## GEORGE HALL MPR AND SUPPORT ROOMS PROJECT #19-143

### ADDENDUM NO. 3

**Date:** November 24, 2021

**LD0.0**

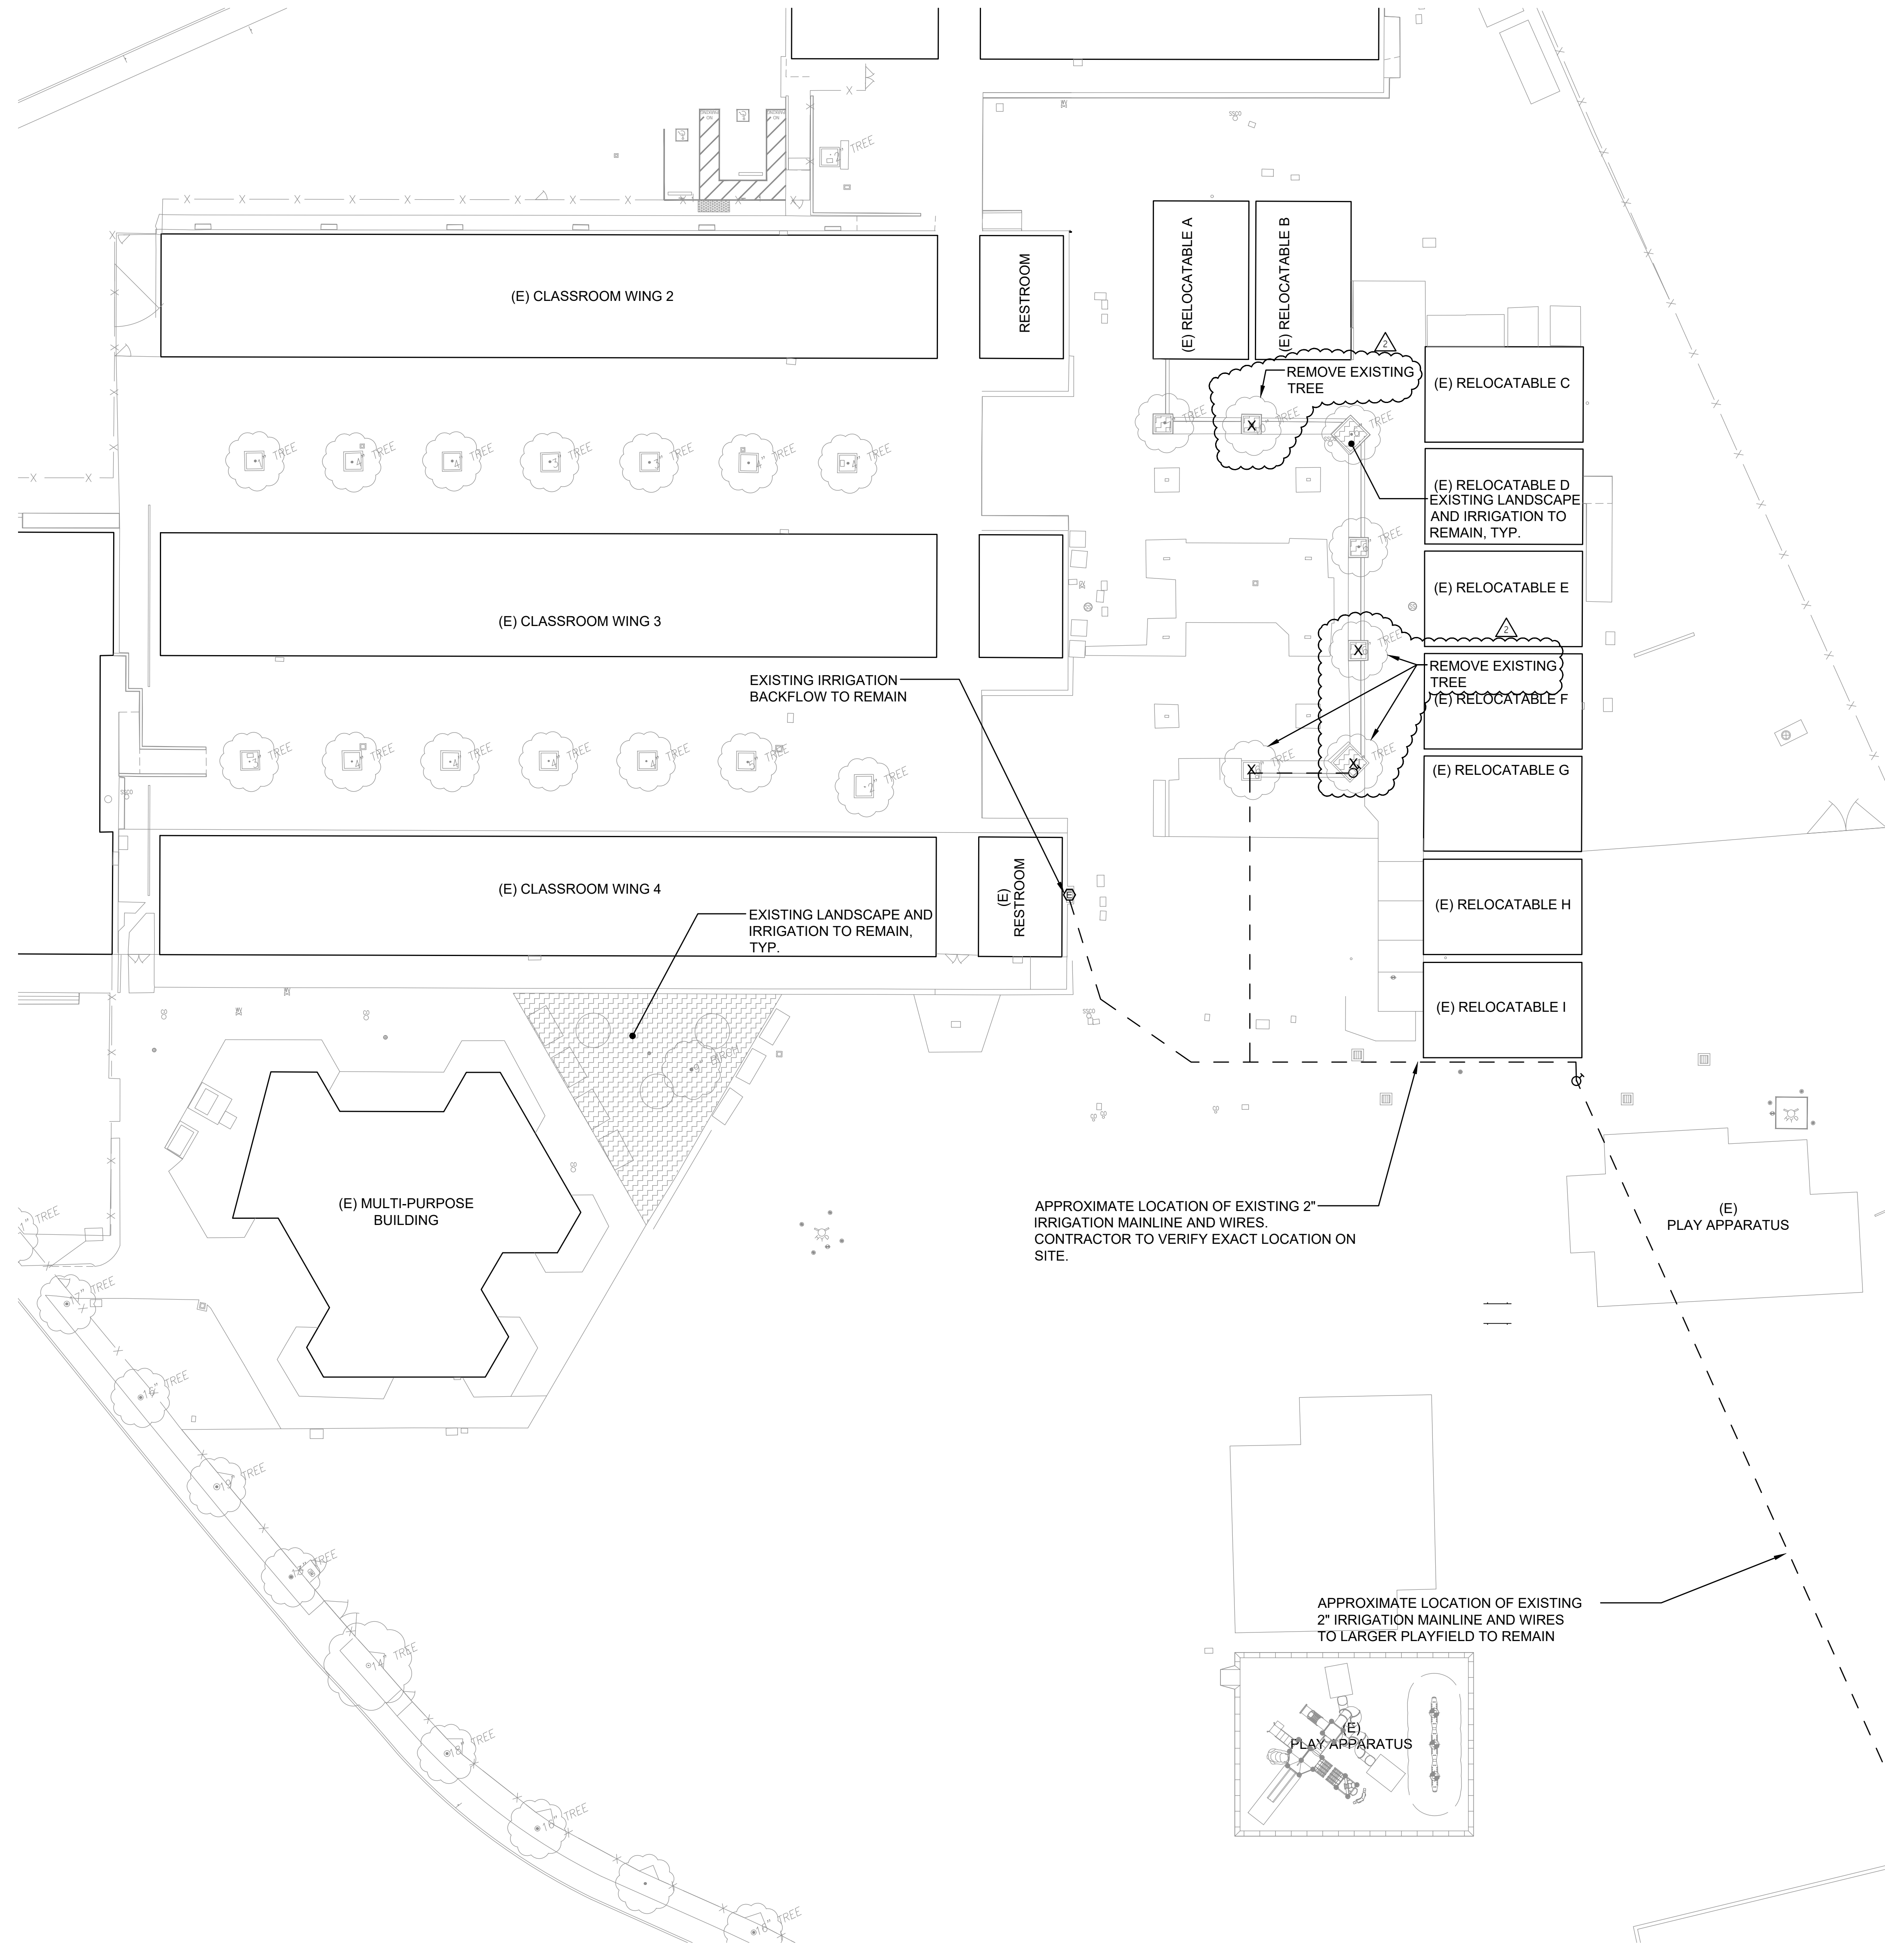
1. **SHEET ‘A10.91 SIGNAGE DETAILS**  
The following drawing is hereby reissued with these changes:  
A. Detail 12 - BUILDING SIGN – Add notes to define dimensional letter
2. **SHEET ‘LD0.0 IRRIGATION DEMOLITION’**  
The following drawing is hereby reissued with these changes:  
A. Demolition Site Plan - Remove (3) existing trees

L1.1

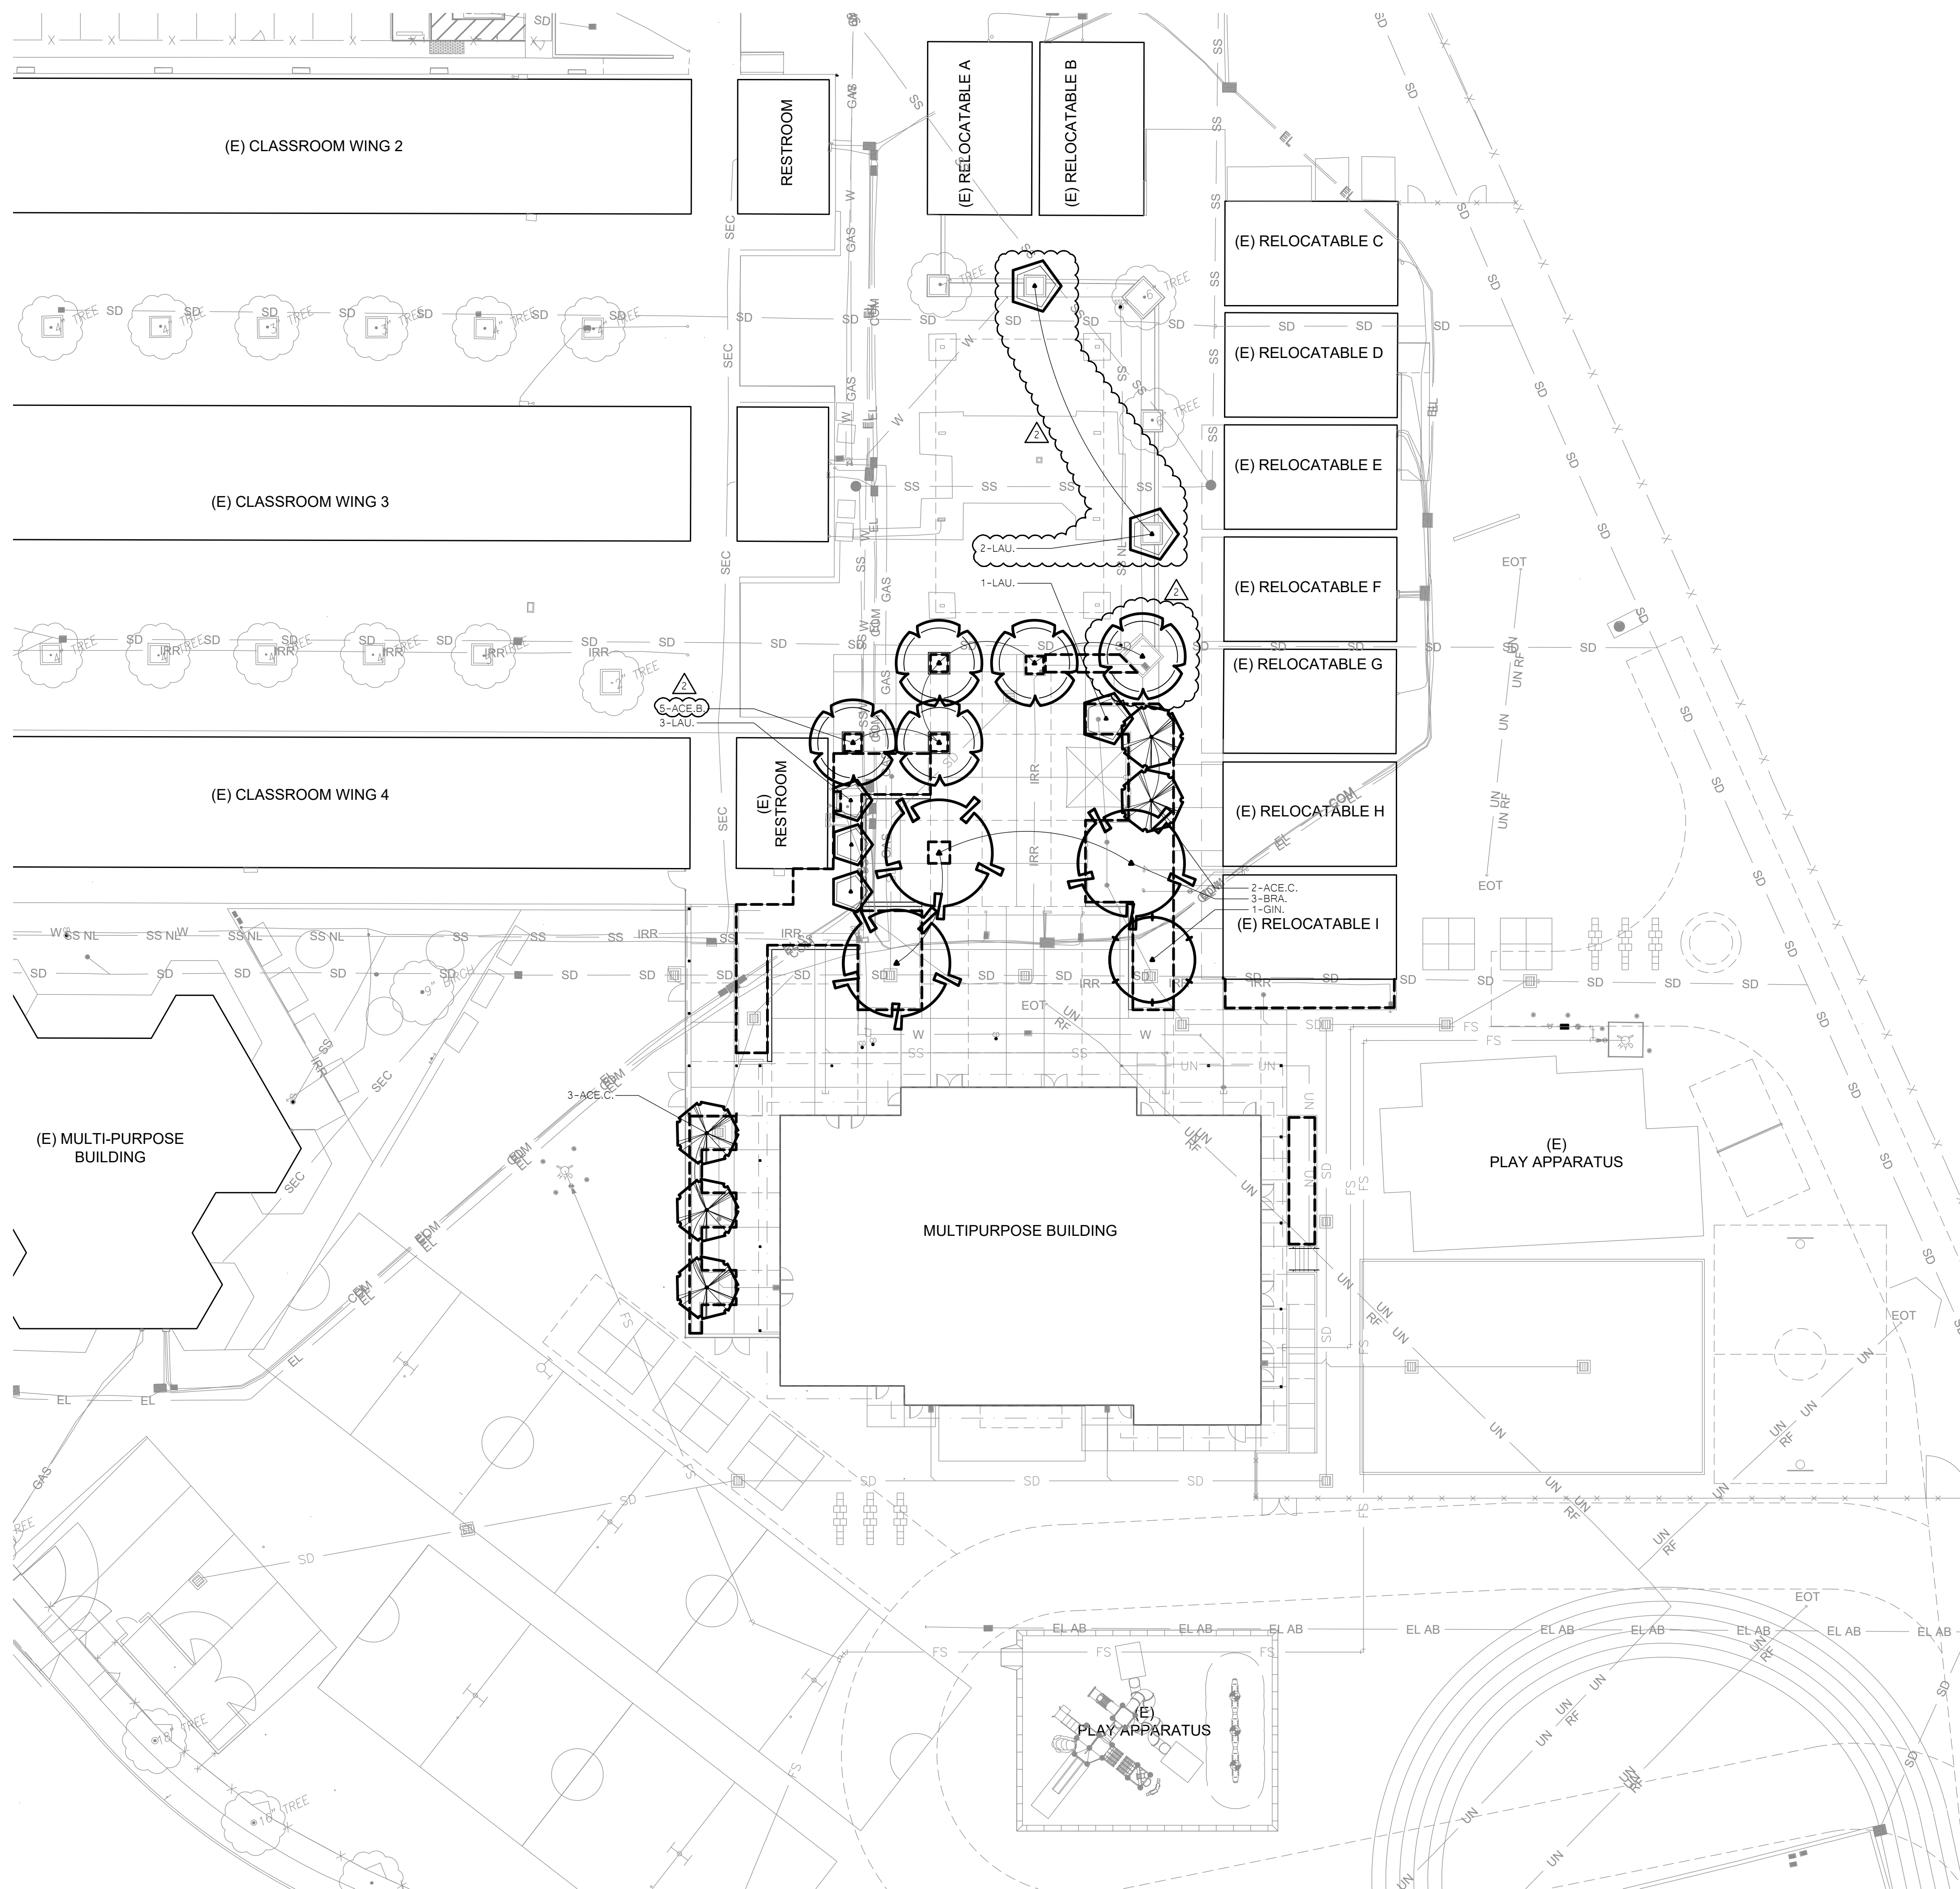
3. **SHEET ‘L1.1 TREE PLANTING PLAN’**

A. Planting Site Plan - Plant (3) trees

L3.1

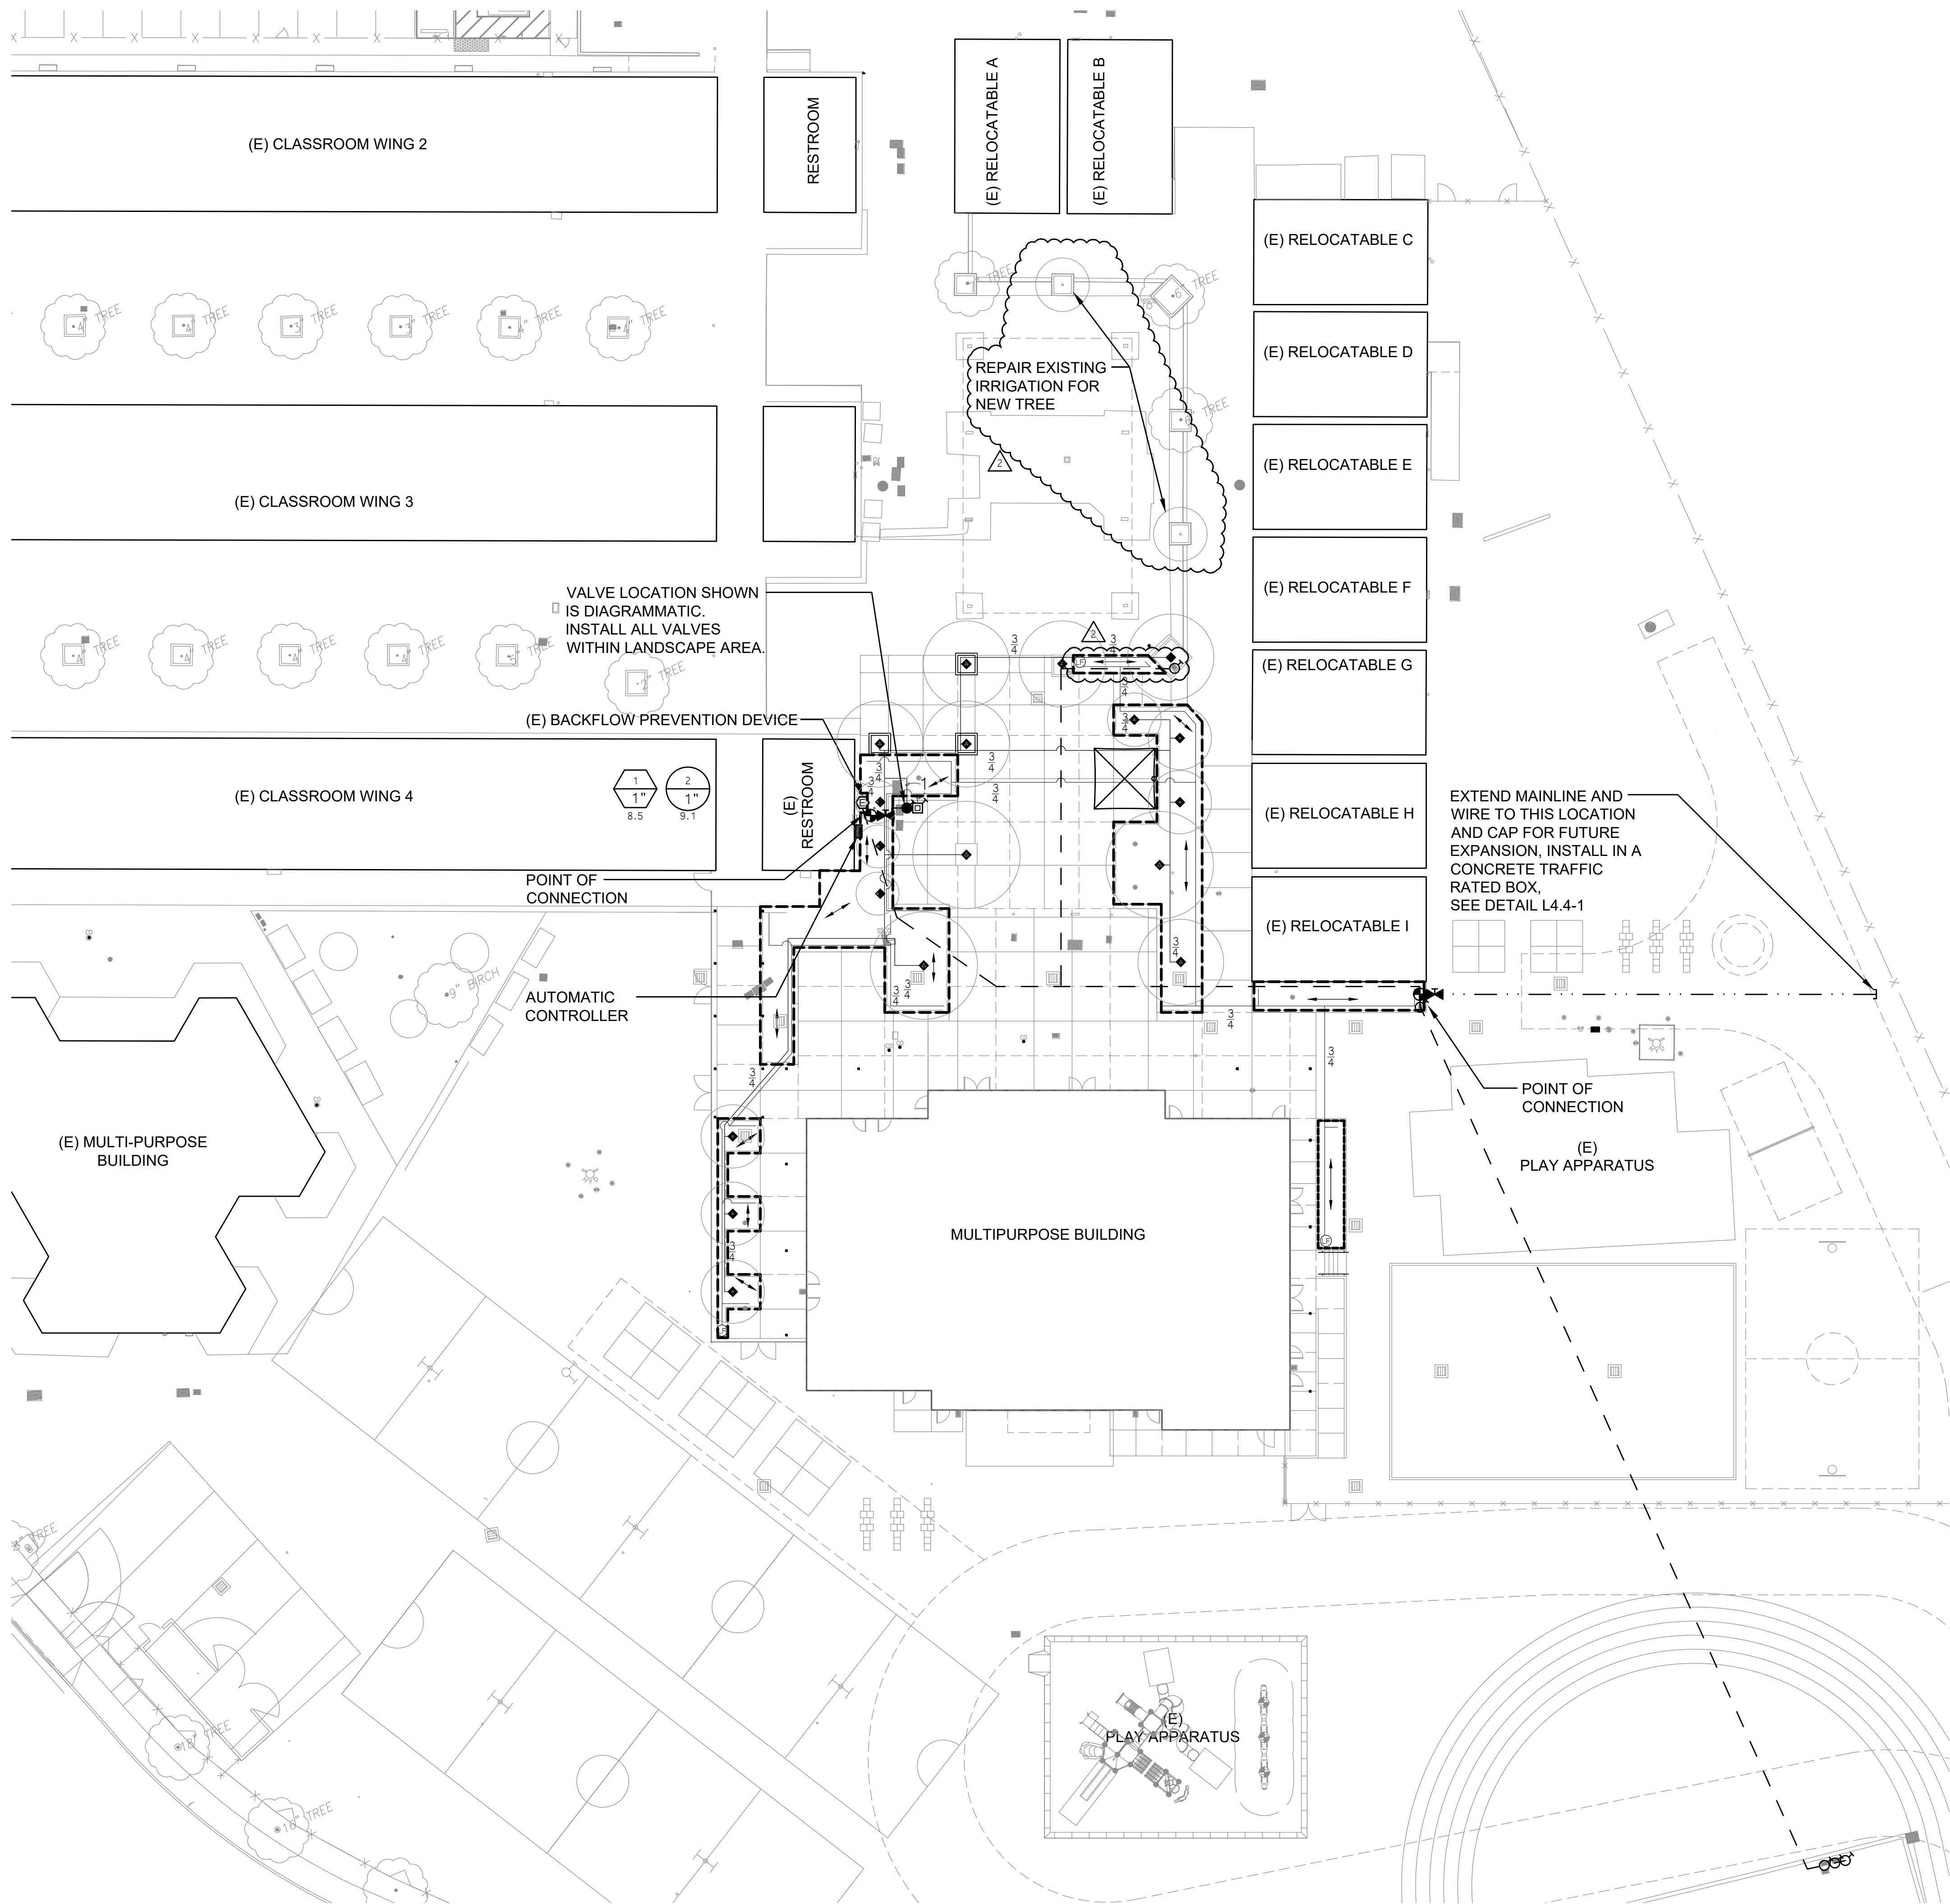
5. **SHEET ‘L3.1 LANDSCAPE IRRIGATION PLAN’**

A. Irrigation Site Plan - Repair existing irrigation
